UNITED STATES PATENT AND TRADEMARK OFFICE

APPLICATION NO.	FILING DATE	FIRST NAMED INVENTOR	ATTORNEY DOCKET NO.	CONFIRMATION NO.
09/982,584	10/17/2001	Jorn von Seggern	400004=2012	7560

Office Action Summary

DETAILED ACTION

Part of Fig. 4 of Greenwell '887

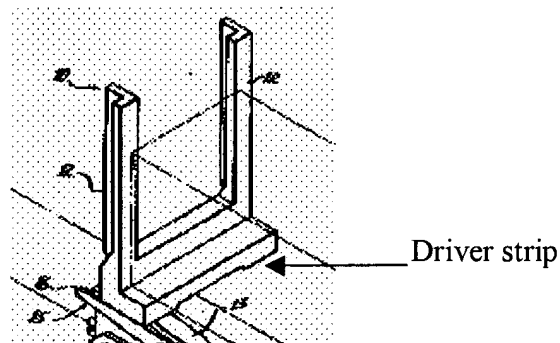
Greenwell discloses all of the claim limitations in a similar conveyor apparatus for transporting objects shown in fig. 4, the apparatus comprising a plurality of continuously circulating guided conveyor lines (20, 20a) with drivers (10,11) arranged at intervals from each

other wherein the conveyor line is constructed of continuously circulating individual chains (20) each of which has respective drivers (10, 11) arranged at intervals from each other, the intervals between the drivers of different individual chains may be adjusted (C4/L20-26) simultaneously. Greenwell further discloses that the drivers (10, 11) are held on each conveyor line (20, 20a) so that they can be adjusted in the direction of transport (C4/L23-26) and that the drivers (10, 11) connected to each conveyor line (20, 20a) are located at fixed intervals from each other (C4/L41-63).

Greenwell additionally discloses that each driver has driver strips (fig. 4) that extend across all of the conveyor lines transversely to the direction of transport.
